The Sizewell C Project

5.2 Main Development Site Flood Risk Assessment Addendum

Revision: 1.0
Applicable Regulation: Regulation 5(2)(e)
PINS Reference Number: EN010012

January 2021

Plate 3.1: Visualisation of the updated SSSI crossing design (extract from Figure 2.2.16 of Chapter 2 of Volume 2 of the ES Addendum (Doc Ref. 6.14))

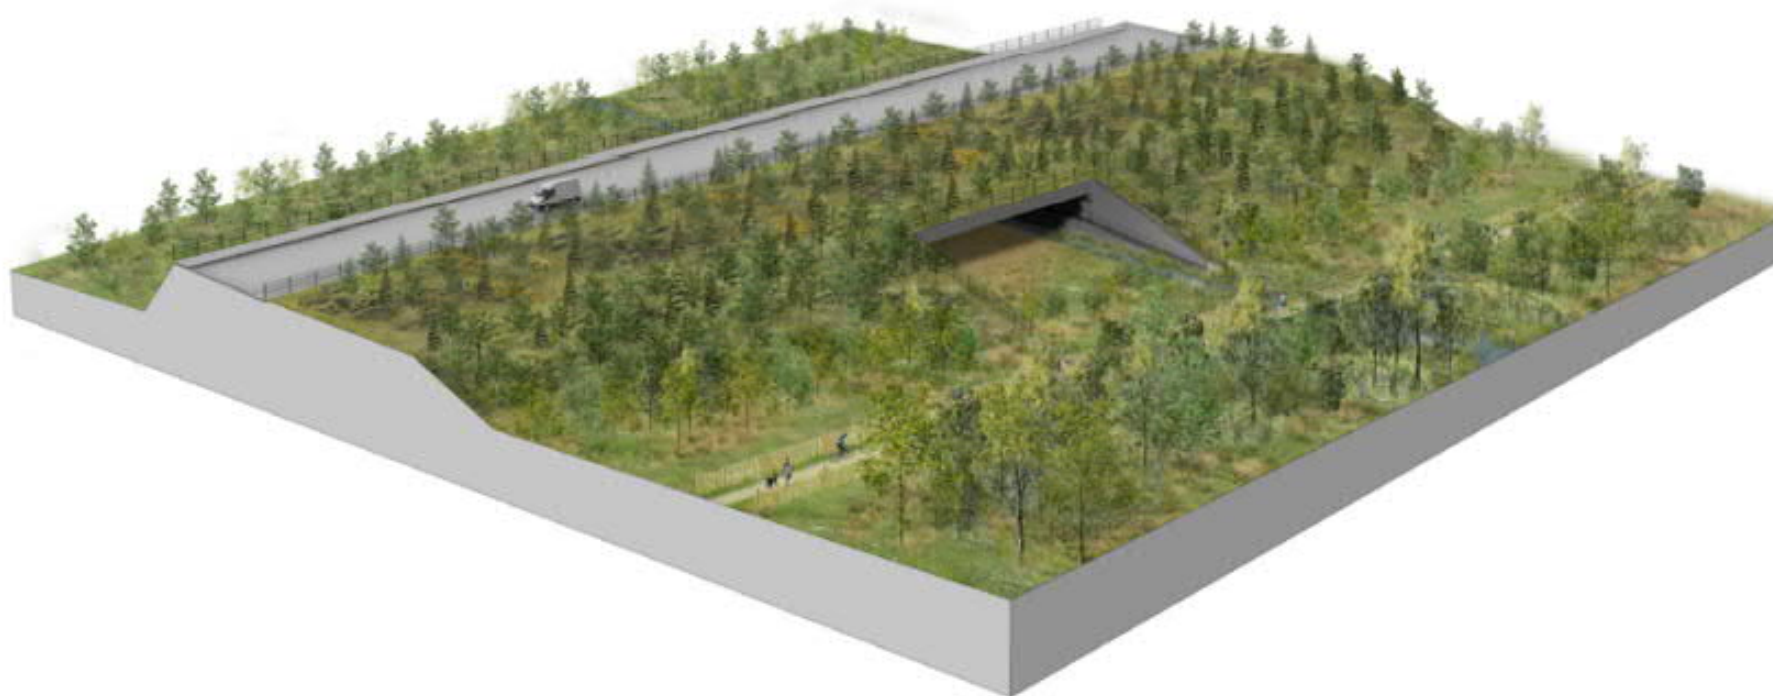
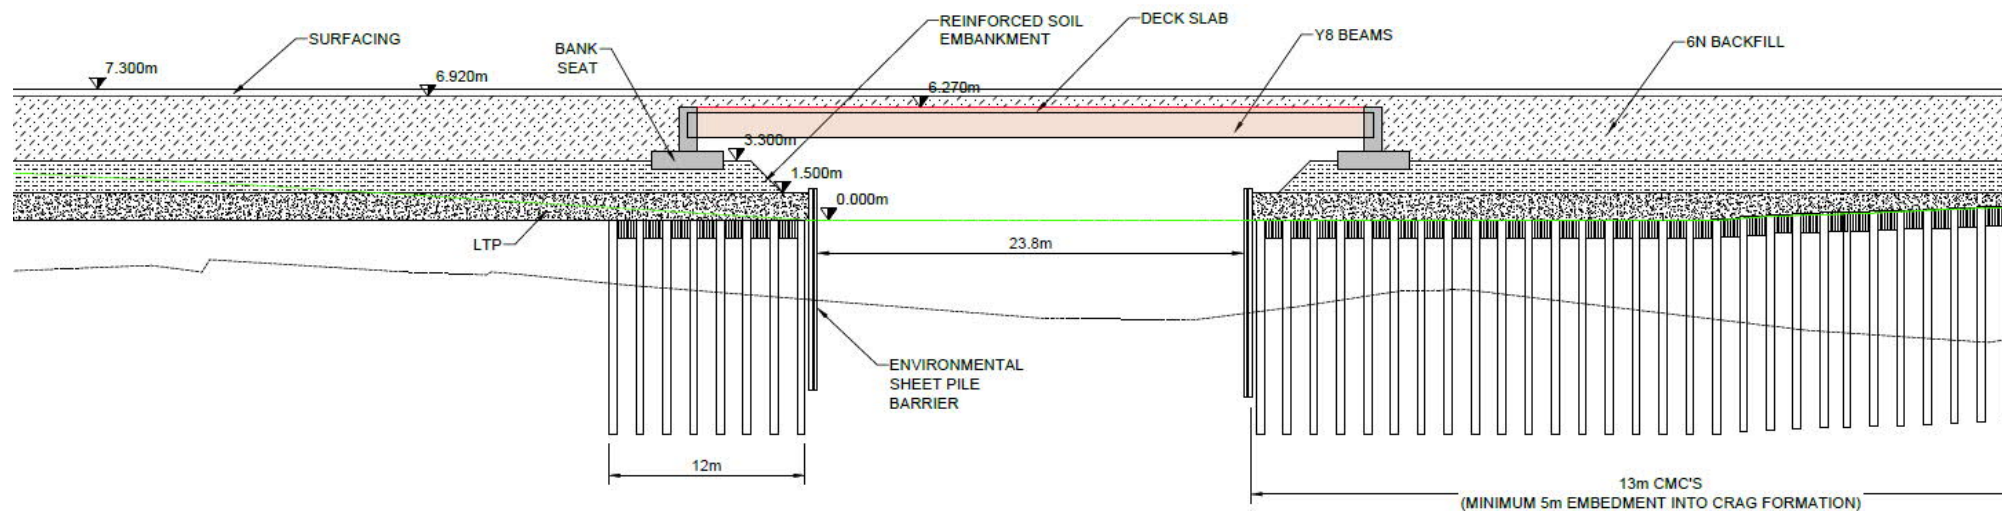
- 3.2.3 To address these concerns, SZC Co. proposes to change the design of the SSSI crossing submitted in the Application. The proposed design comprises a 30m wide single span bridge with separate embankments at either end of the SSSI crossing and a soffit raised to a level of 4.35m AOD. This will provide additional flood relief and ecological connectivity,

alongside less SSSI land-take (reduction of approximately 450m²), compared with the current design.

Plate 3.3: Proposed habitat and flood mitigation area (extract from Figure 2.2.14 of Chapter 2 of Volume 2 of the ES Addendum (Doc Ref. 6.14))

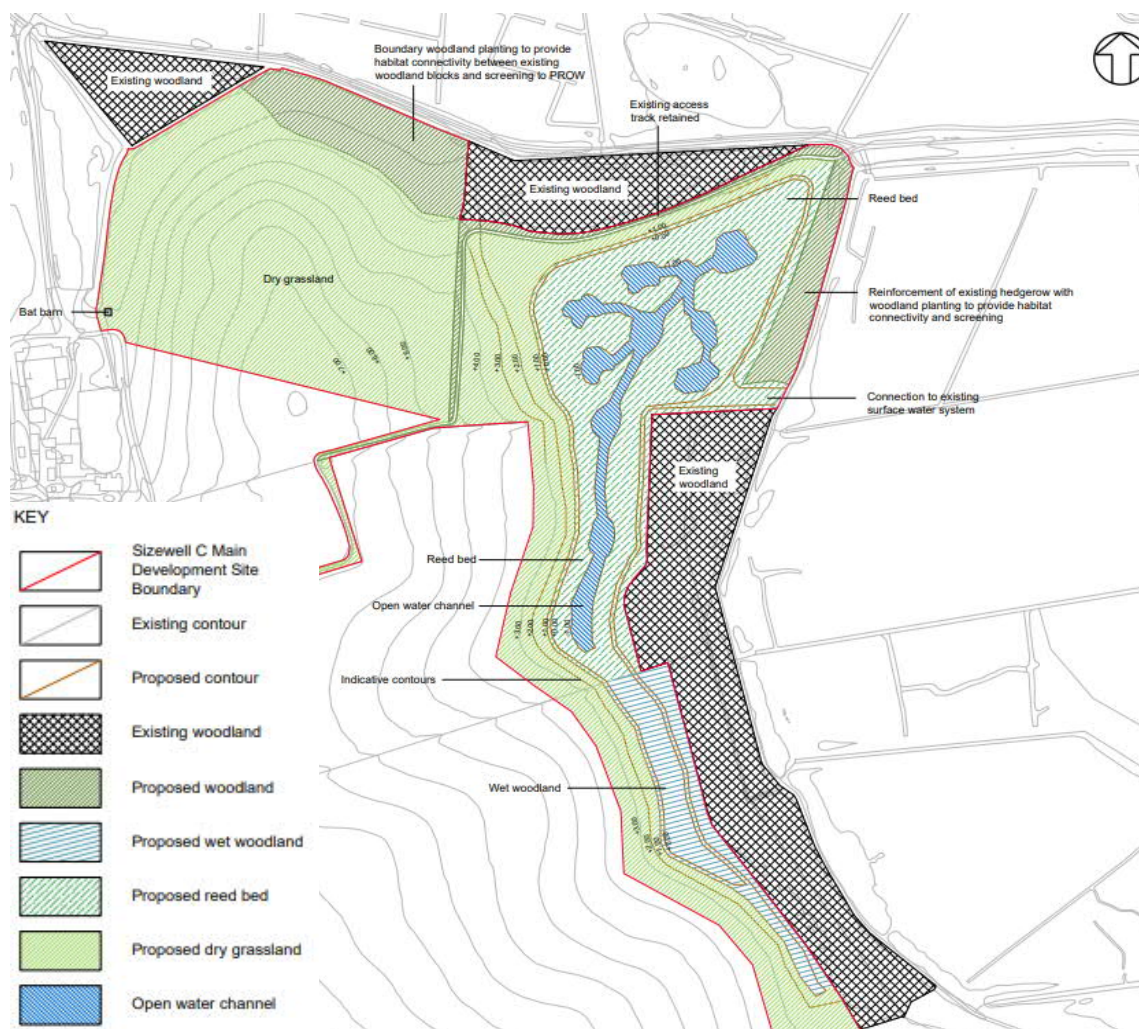
- 3.2.8 This proposed change would allow the area and volume associated with the water resource storage area's original location to instead provide permanent wetland habitat and up to approximately 100,000m³ for flood mitigation (considering available storage up to 3m AOD contour line). The wetland habitats would be open water channels and wet reedbeds to provide high quality foraging habitats for marsh harriers.

- 3.2.9 The proposed change would introduce embedded flood mitigation for storage loss caused by the development on parts of the main platform area and by the SSSI crossing embankments. This development type is classed as water compatible development and therefore appropriate for location within Flood Zone 3.

- 3.2.10 The flood mitigation area would be linked to the proposed permanent wetland habitat corridor immediately to the south to create a single integrated wetland feature, as illustrated in **Plate 3.3** below.

Plate 4.2: Alignment of the temporary sheet pile wall and breach for BLF access road

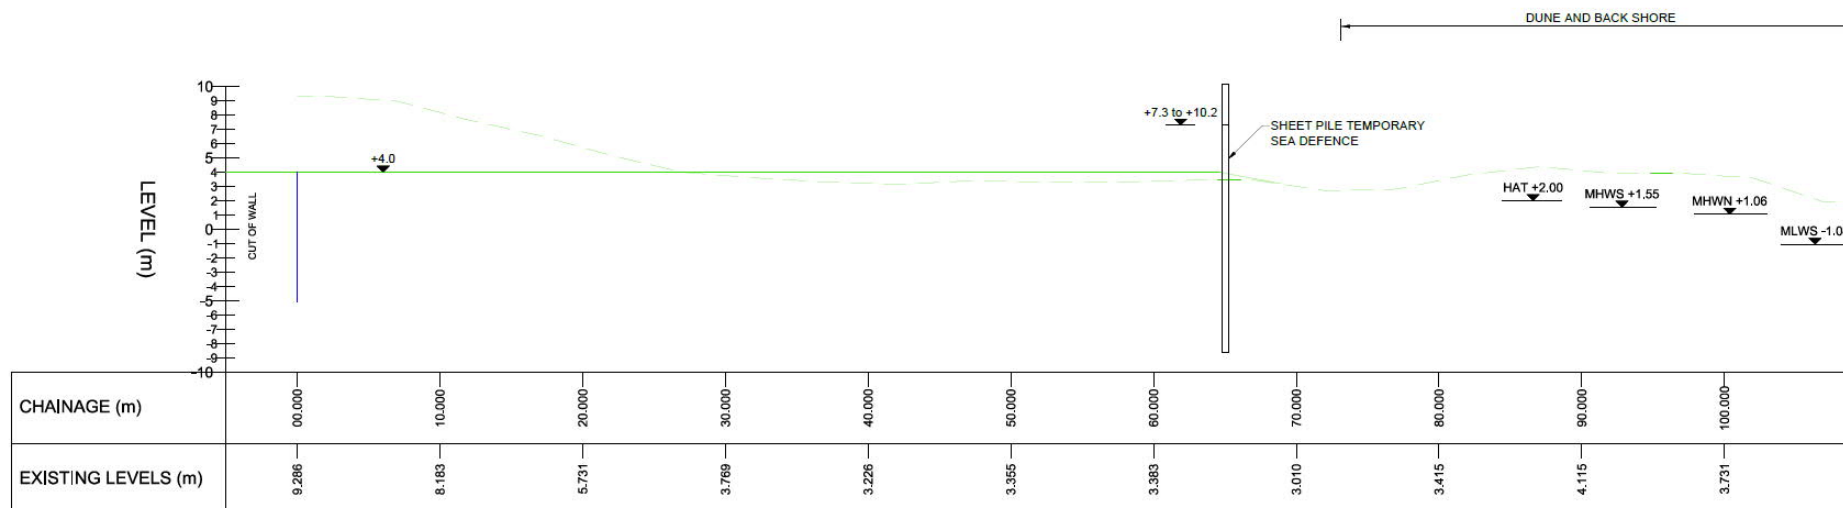
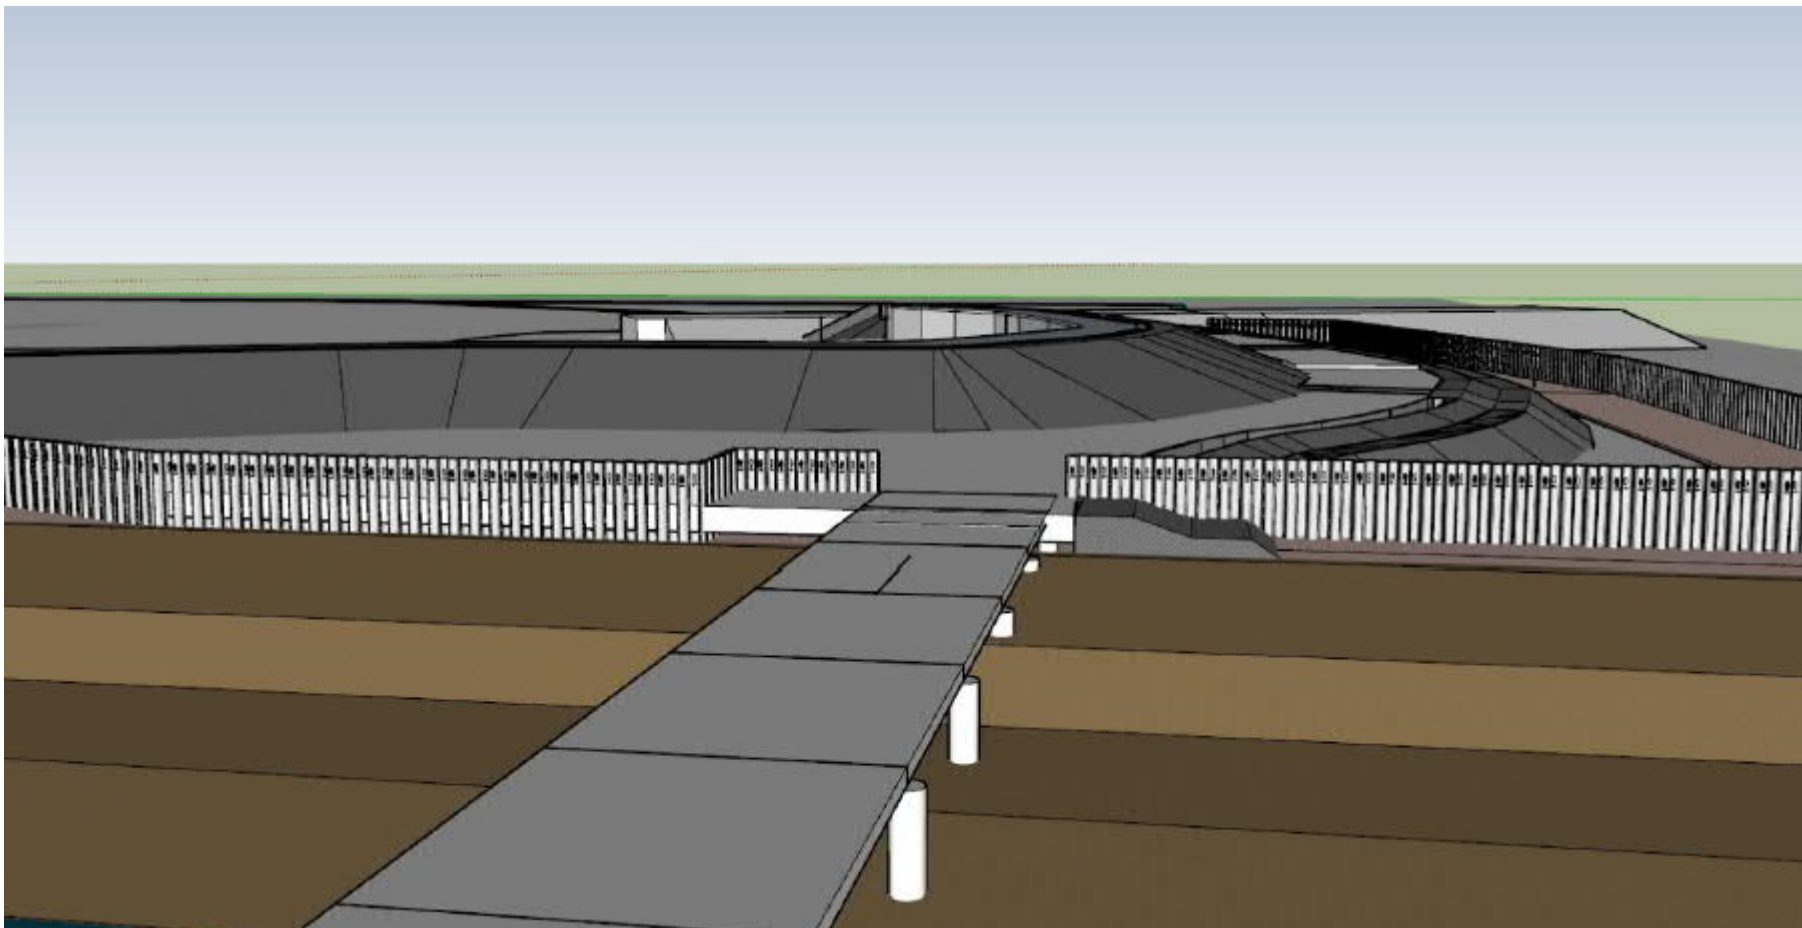
- 4.2.6 Following the Application submission, further design and construction sequencing works have been undertaken giving more detailed information. A change in design is proposed, where a temporary sheet pile wall around the construction area would be installed, extending from the Sizewell B defence to another temporary sheet pile wall at the SSSI crossing construction area. The sheet pile wall would have a crest set at a minimum level of 7.3m AOD, as illustrated in **Plate 4.1** improving management of flood risk during early construction phase when compared with the approach presented in the Application.

- 4.2.7 The temporary defence would be installed prior to the removal of any existing defences and would remain in place until the core of the permanent defence would be completed, as illustrated in **Plate 4.2**. The temporary defence would be breached to allow access to the permanent Beach Landing Facility (BLF); however, this would only happen after the reinforced core of the permanent defence has been constructed up to a minimum level of 9.1m AOD.

Plate 4.3: Proposed Permanent HCDF cross-sectional profile (extract from EDF Energy drawing no. SZC-EW0601-XX-000-DRW-400025 rev. 01, 27/11/20)

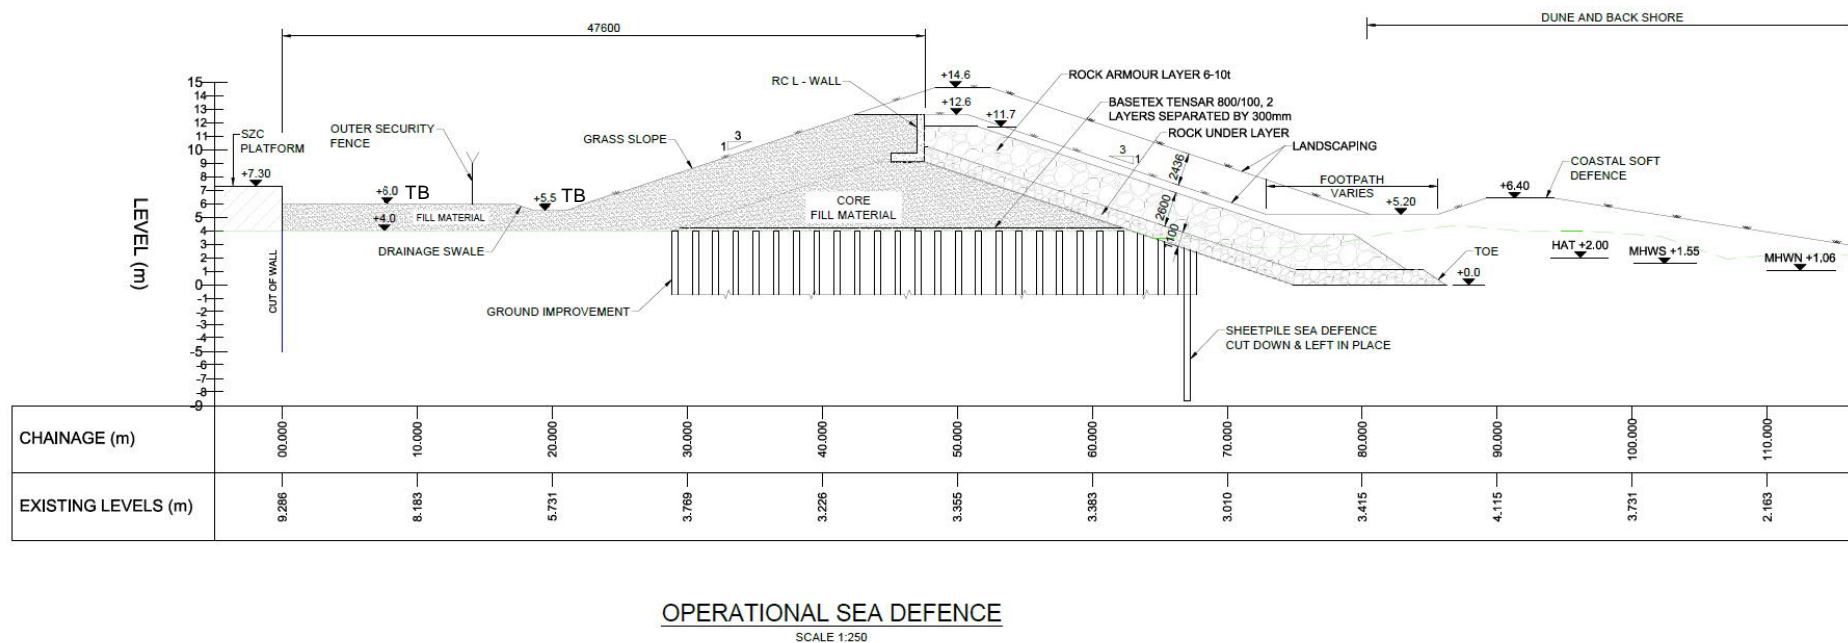
- 3.1.9 Correspondingly, in order to delay future HCDF raising activities, and to take account of the revised design basis limit for the HCDF, a revised initial height of 12.6m AOD (from 10.2m AOD minimum crest height presented in the Application) has been established for both the HCDF and Northern Mound. This gives a total height with landscaping of up to 14.6m AOD. The permanent HCDF design retains the ability to raise the sea defence further to mitigate this risk with the maximum crest height of 16.4m AOD. These design changes have been set out in **Chapter 2 of Volume 2 of the ES Addendum** (Doc Ref. 6.14).

Plate 4.4: Proposed Adaptive Sea Defence (HCDF) cross-sectional profile (extract from EDF Energy drawing no. SZC-EW0601-XX-000-DRW-400025 rev. 01, 27/11/20)

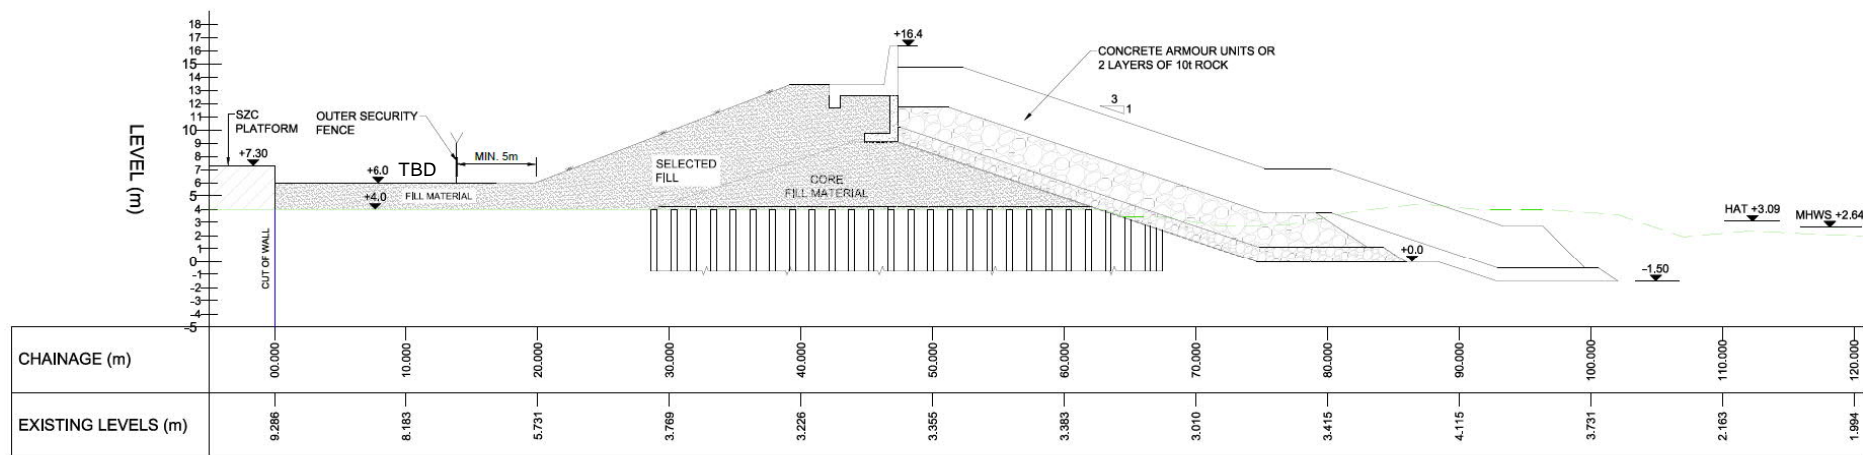
- 4.2.17 Beyond 2140 epoch, the adaptive defence would be constructed (shown in **Plate 4.4**), as required, to comply with the Nuclear Site Licence, depending on the trajectory of current climate change projections and decommissioning activities.

Plate 5.1: Water Management Zone 1 (edged in purple) (extract from SZC Co. Consultation Document (Doc Ref. 5.1Ad [APP-068])

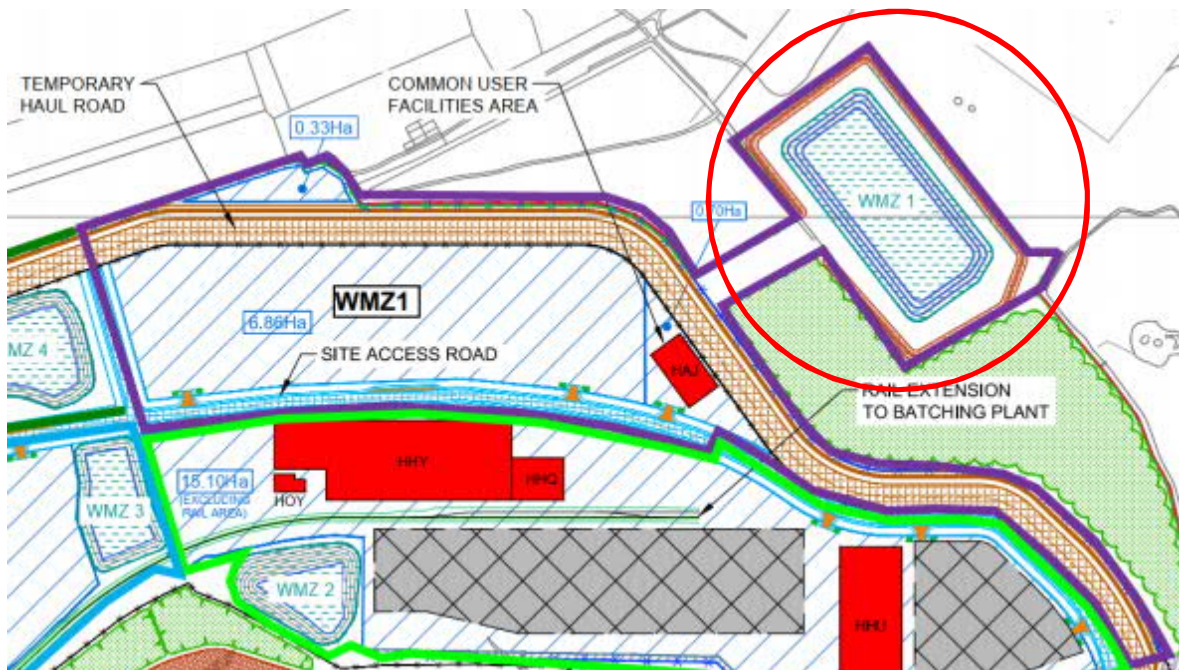
Sizewell C Main Development Site FRA	Fig 33, 9.2.13 and Fig 56 and 9.3.3	Water Management Zone 1 basin is shown to be at fluvial risk in the 1000yr (and to a lesser extent the 200yr) extent in the baseline scenario, however, in the with scheme mapping, the proposed basin acts as the boundary for the flood extent.	The proposals should be made clear. Will proposed raised embankments create the boundaries of the flood extents? If so, the updated flood extents must be demonstrated. Figure 56 indicates that this location would be inundated in the future 100year flood events, based upon upper end and credible maximum scenarios.	Provide plates and figures showing flood risk and the construction site location. Illustrate the flood risk for the areas of the construction site that are at risk (depth, hazard & velocity). Confirm mitigation measures if required.

5.1.4 WMZ-1, presented in the Application (**Outline Drainage Strategy** proposed in **Volume 2, Appendix 2A** of the **ES**) and shown in **Plate 5.1**, is part of the surface water drainage strategy for the proposed temporary haul road during construction as well as part of the site access road. The detention basin that forms part of the design (marked with a red circle in **Plate 5.1**) will allow infiltration prior to the construction of the CDO and will be retained for exceedance storms and balancing excess volume that exceeds infiltration capacity throughout the construction phase.

- 5.1.5 As discussed in **section 4.2iii**, during the early years when the construction areas are being created, the CDO would not yet be complete. In order to provide additional flexibility and resilience in the management of surface water, a temporary outfall is proposed for approximately a 2-year period. This would be used to discharge surface water from the main platform area out to the sea reducing pressure on WMZ-1 and managing surface water flood risk within the main platform construction area. It is assumed that the temporary outfall would typically only be used when surface water is captured in the construction site which cannot be discharged through infiltration or to the surrounding watercourses. The Application assumed that there would be no temporary outfall during the construction phase.

- 5.1.6 The detention basin would comprise an earth bund with a crest above maximum flood levels during construction phase. As such, this configuration was included in the hydraulic modelling assessment in the Application, which showed slight encroachment into the fluvial flood extent for the 1 in 100-year and 1 in 1,000-year return period fluvial events, indicating therefore that the bund would form a boundary of the flood extent for these scenarios. However, this would only be the case during the construction phase of the development, as WMZ-1 will be a temporary feature and removed at the end of the construction phase.
